**Variance Application**  
**from the San Juan County Subdivision Regulations**

RE: Cal-Stock Subdivision - Paving Variance

Re: Cal-Stock Subdivision – Preliminary Plan Review

Re: Cal-Stock Subdivision – Preliminary Plan Review

Project Name: Cal-Stock Subdivision, San Juan County, NM      Date: 03/04/2020  
 Reviewer: WSP      Preparer: Govinda Karki, PE / Farshad Omidvaran, PE  
 Consultant: CHC Engineers      Project No. \_\_\_\_\_  
 Document Type Subdivision Review      Review No. 114

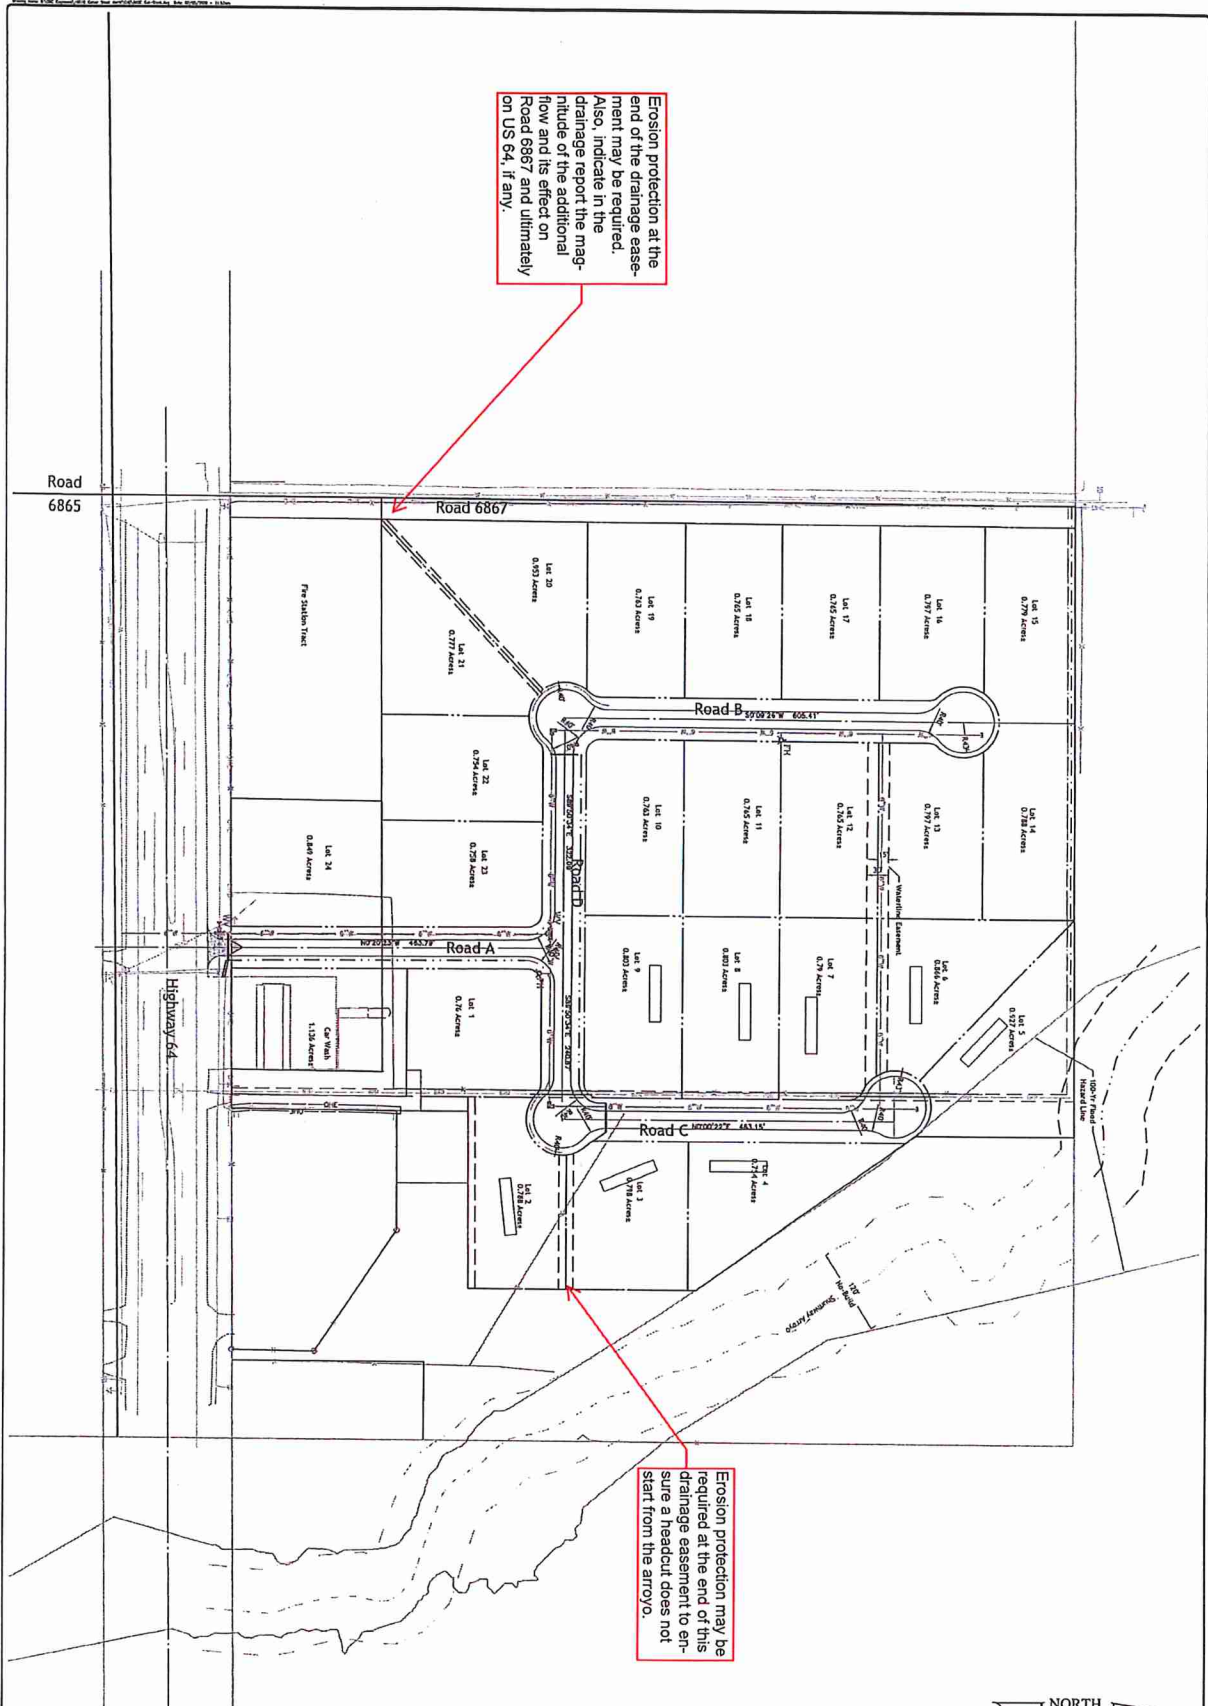
COMMENT #	COMMENTS
1	Section 2 (Drainage Design Criteria) of the Drainage Report for Cal-Stock Subdivision specifies the use of the Rational Method for the hydrologic analysis while the calculations shown under Appendix B are based on the Simplified Peak Flow method. In addition, the rainfall estimates and other calculations are based on the older 1995 version of the NMDOT Drainage Design Manual. The analysis for this subdivision should be based on the July 2018 (latest version) of the NMDOT Drainage Design Manual.
2	Pre- and post-development runoff should be compared to ensure no addition flow goes into NMDOT right-of-way or existing culvert(s). The analysis should clearly show that the historic flows getting to the NMDOT facilities are maintained or the additional flows are mitigated. The drainage patterns for the proposed subdivision have three outfalls; one directly down Road A and two other outfalls down the proposed drainage easements. The pre- and post-development flows for each of these outfalls should be evaluated separately and mitigation for increased flow, if any, should be provided.

3	Minimum culvert size, culvert slope and flow velocity criteria for structures within the NMDOT right-of-way should be as per Section 205 of NMDOT Drainage Design Manual. Minimum pipe cover should be as per the NMDOT standard drawings. See attached Cal-Stock Subdivision plan – Drainage Review Comments.

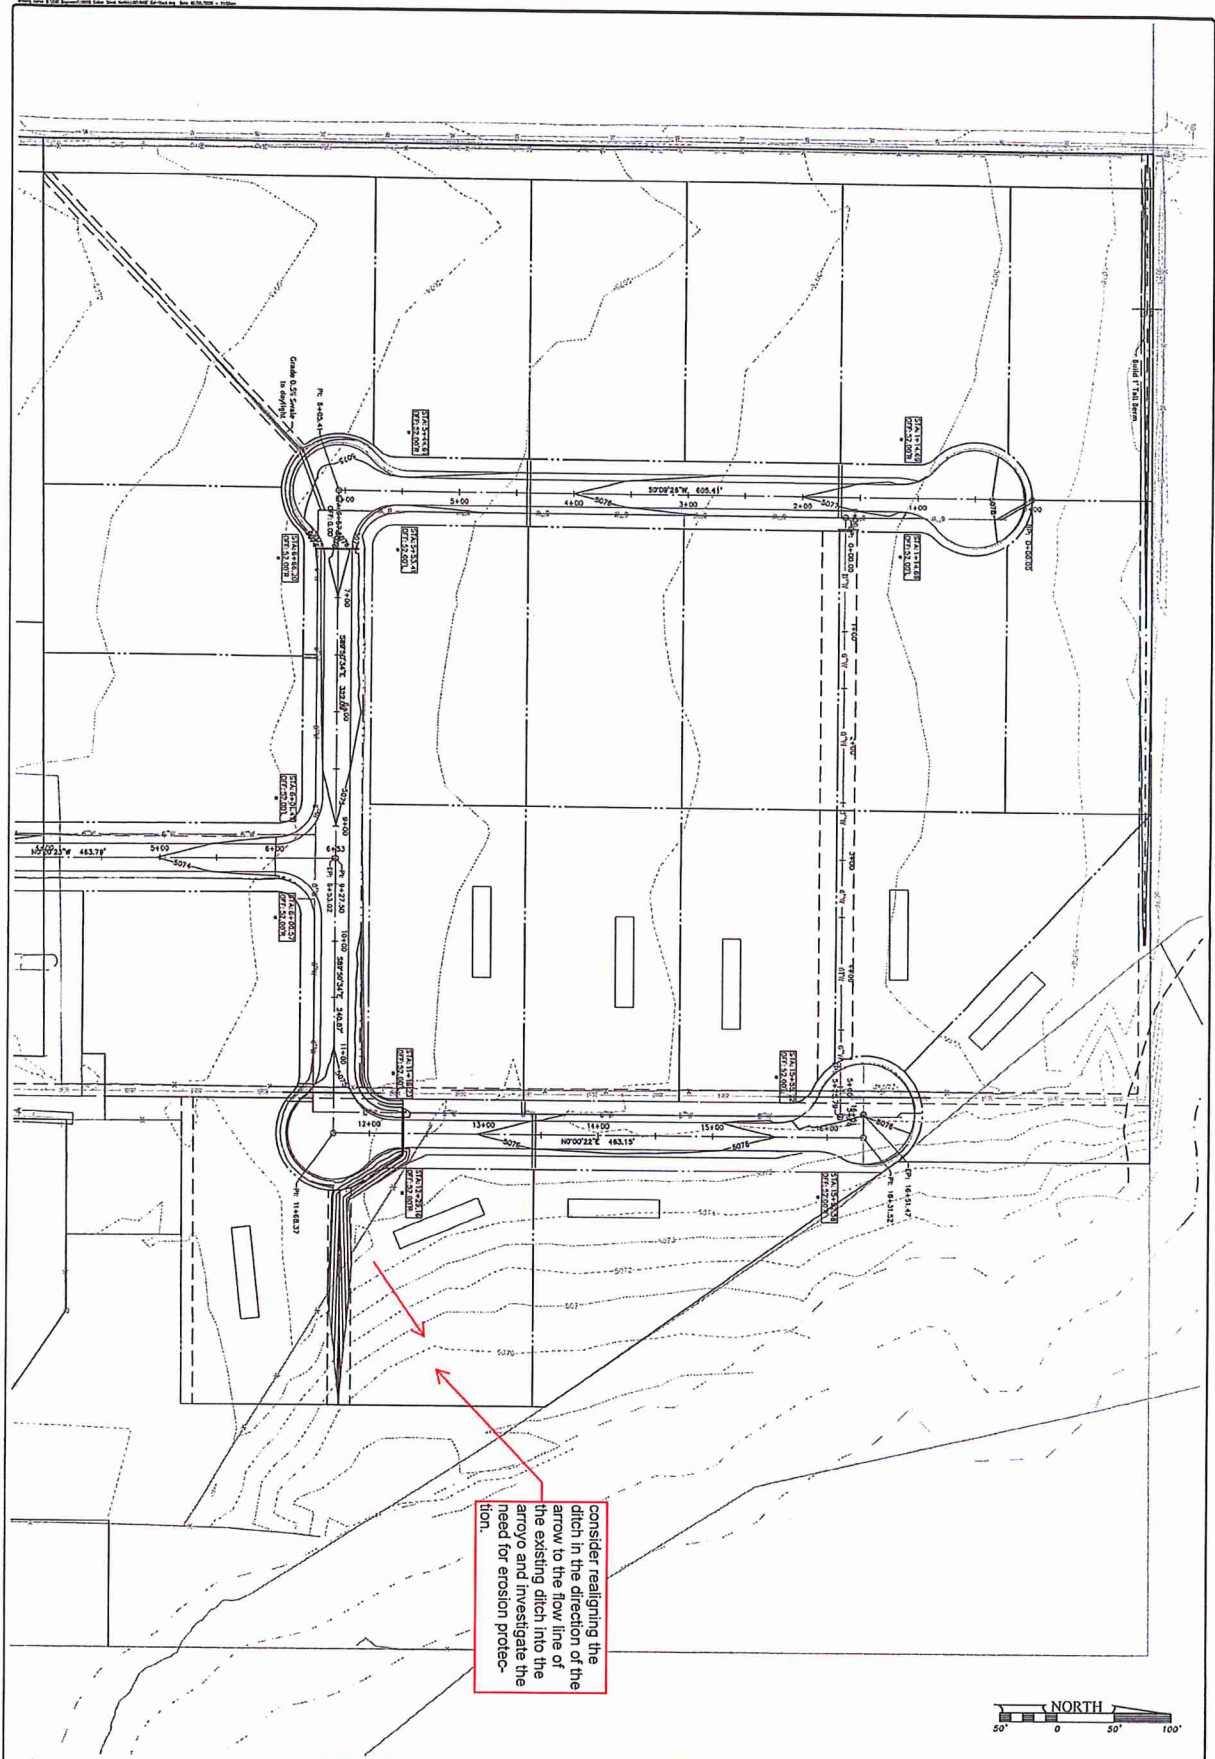
Erosion protection at the end of the drainage easement may be required. Also, indicate in the drainage report the magnitude of the additional flow and its effect on Road 6867 and ultimately on US 64, if any.

Erosion protection may be required at the end of this drainage easement to ensure a headcut does not start from the arroyo.

<b>Revision Log</b> 1 2 3 4 5 6 7	<b>Owner:</b> Lawrence J Stock Revocable Trust	<b>Project:</b> CAL-STOCK SUBDIVISION	<b>Sheet Description:</b> ROADWAY PLAN AND PROFILE	 <b>Ode Engineers, LLC</b> 30 Valley Court 780-335-3100 2/27/2020 Project Date: 2/27/2020 Proj. Name: 3-2
--	---	--	---	---

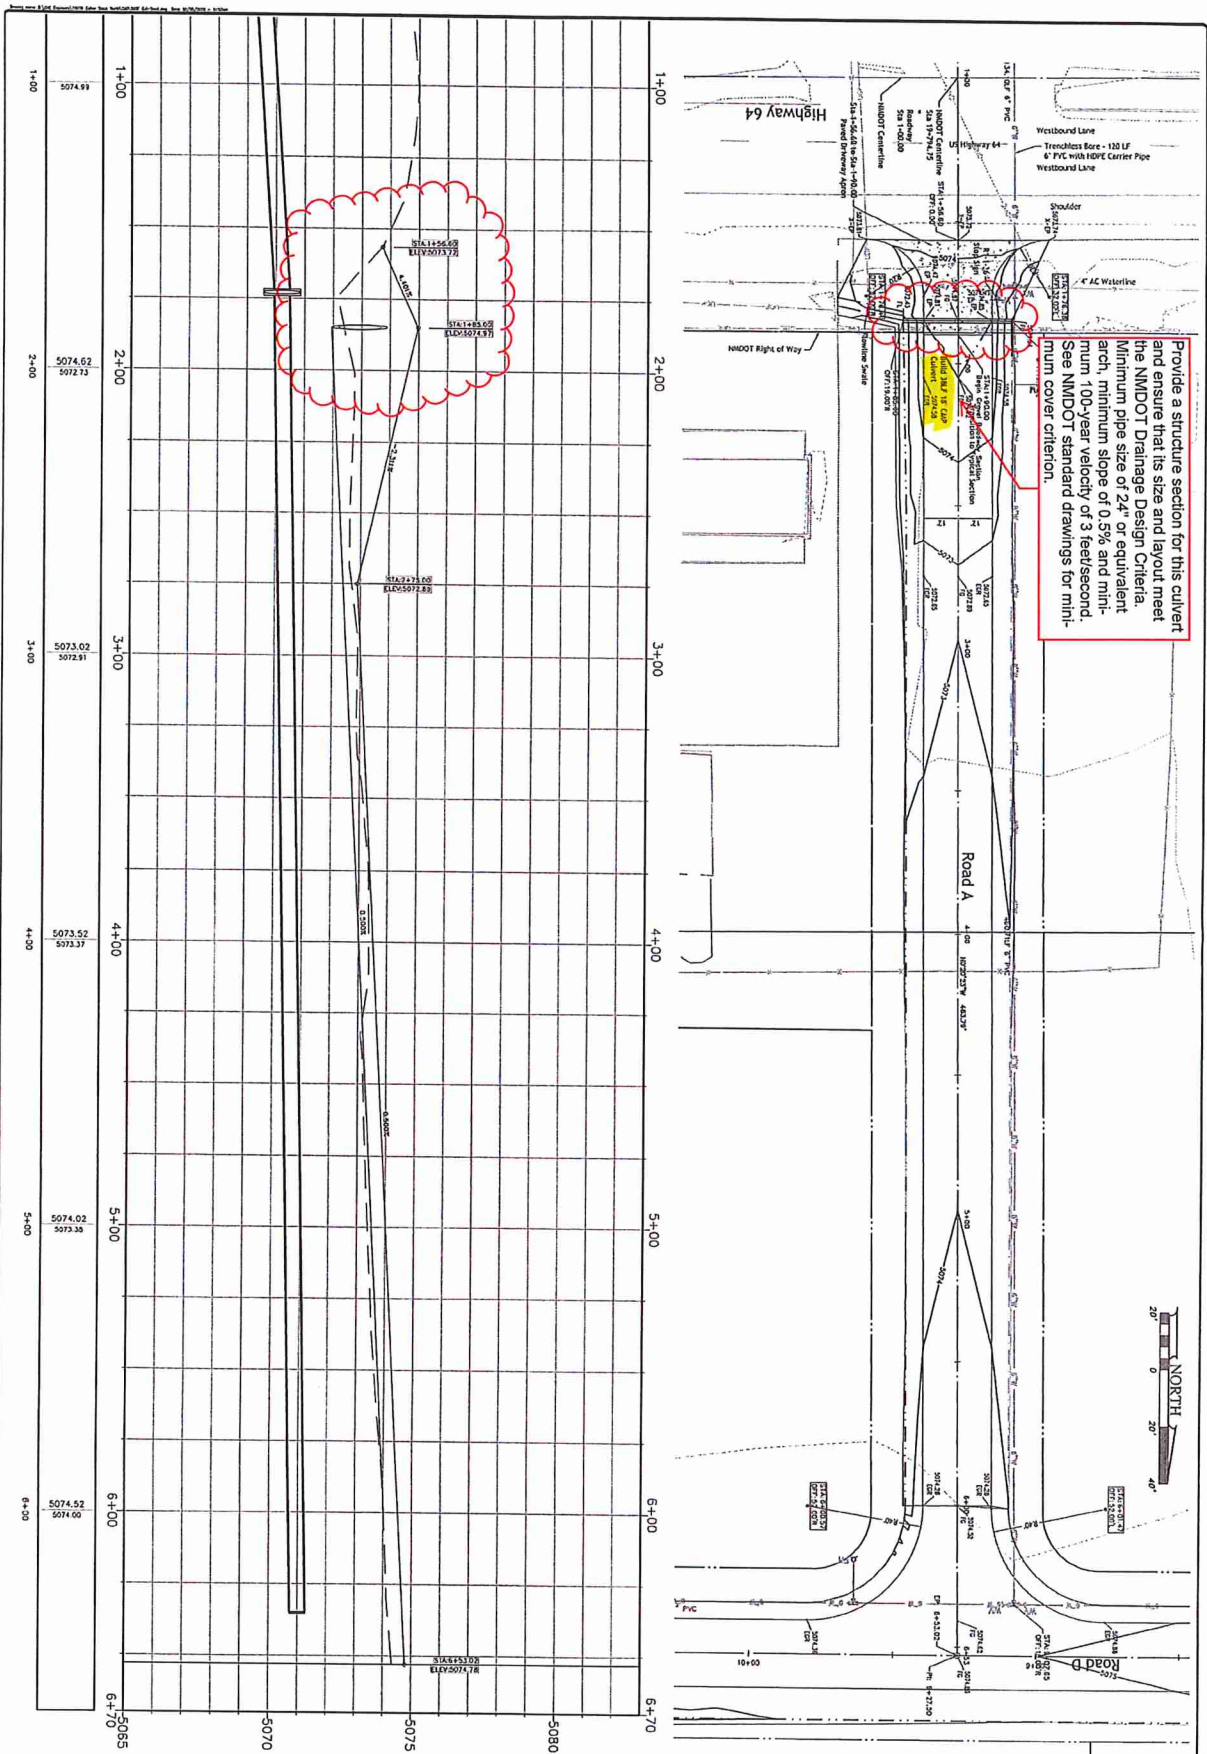
Provide a structure section for this culvert and ensure that its size and layout meet the NMDOT Drainage Design Criteria. Minimum pipe size of 24" or equivalent arch, minimum slope of 0.5% and minimum 100-year velocity of 3 feet/second. See NMDOT standard drawings for minimum cover criterion.

ES Engineering, LLC 20 Valley Court Denver, CO 80202 303.733.1100 3/15/2020	Draft Prepared Not for Construction	Sheet Description	Project	Owner	Revision Log 1 2 3 4 5 6 Plot Date: 02/01/2020 - 11:52am
		ROADWAY PLAN AND PROFILE	CAL-STOCK SUBDIVISION	Lawrence J Stock Revocable Trust

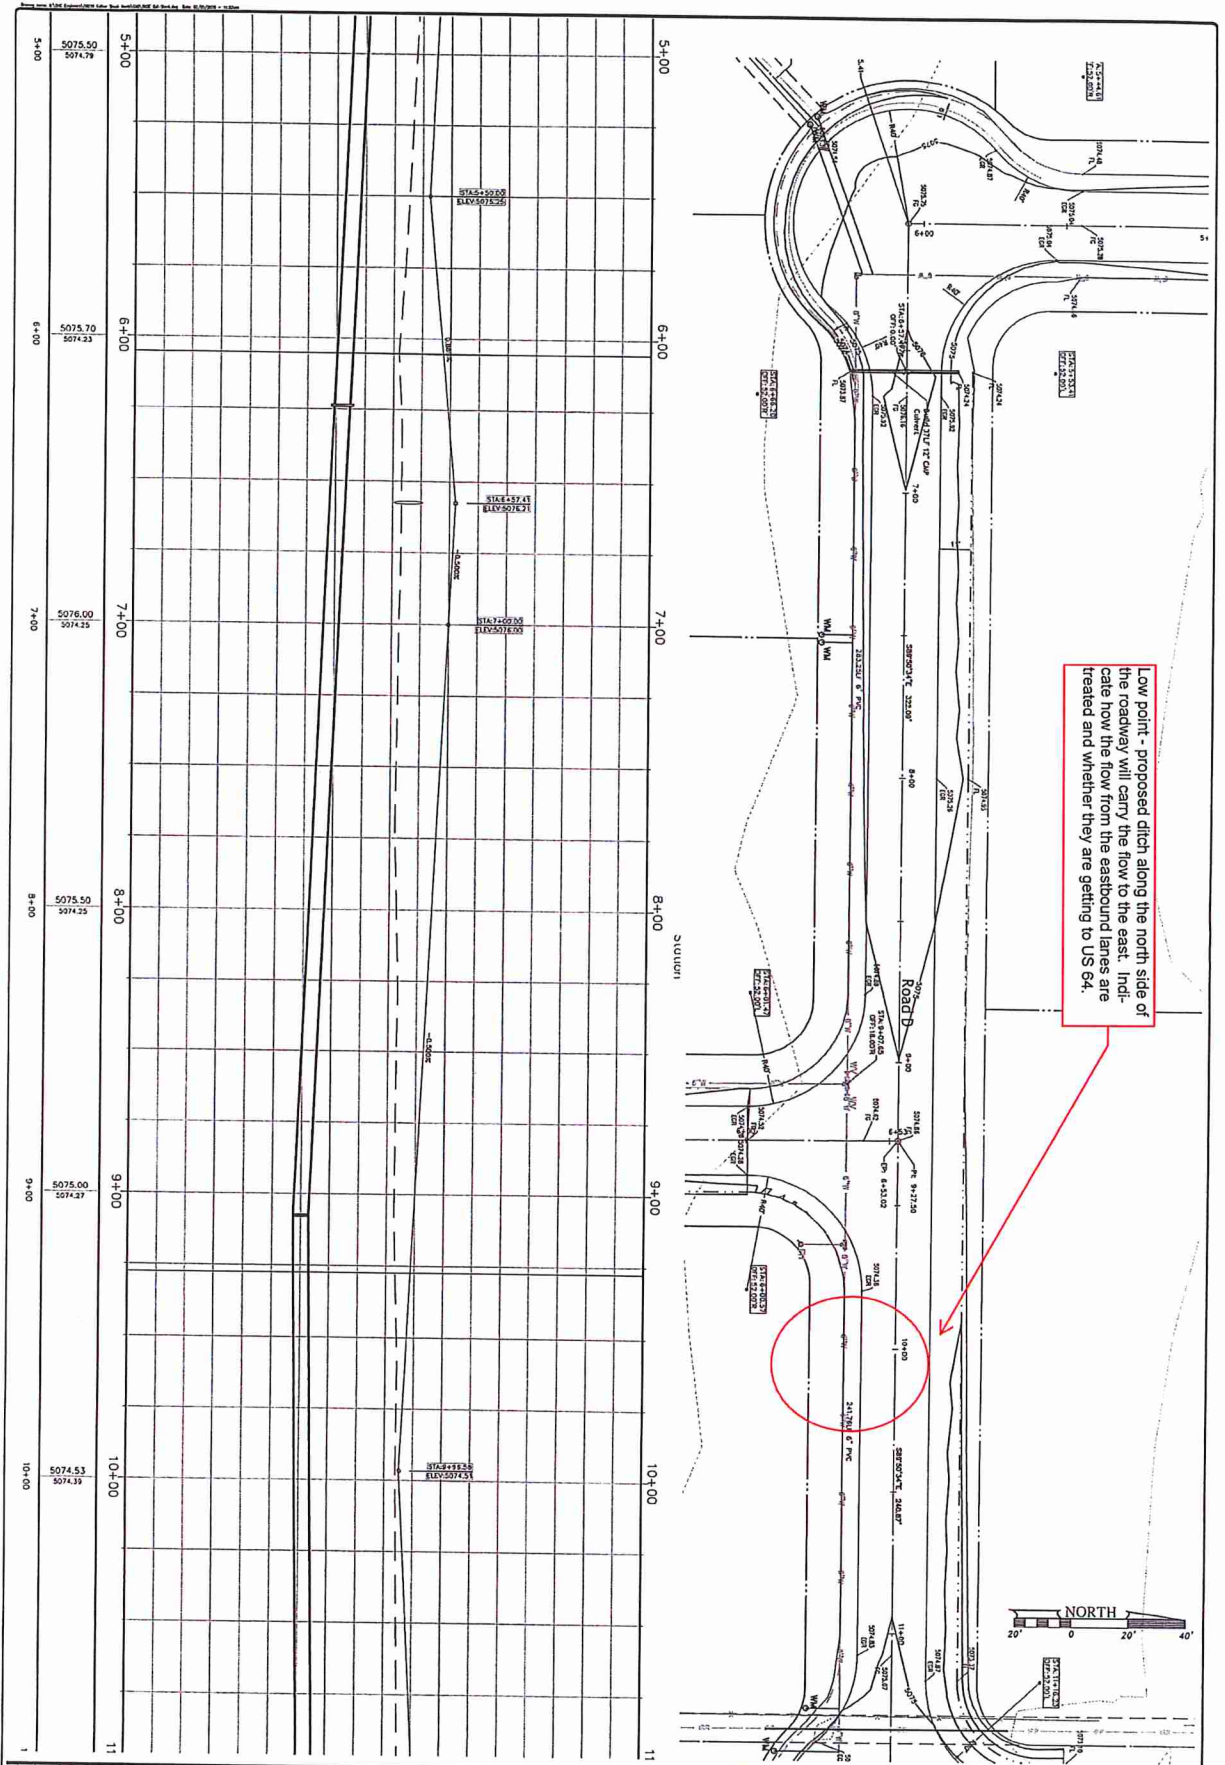
Low point - proposed ditch along the north side of the roadway will carry the flow to the east. Indicate how the flow from the eastbound lanes are treated and whether they are getting to US 64.
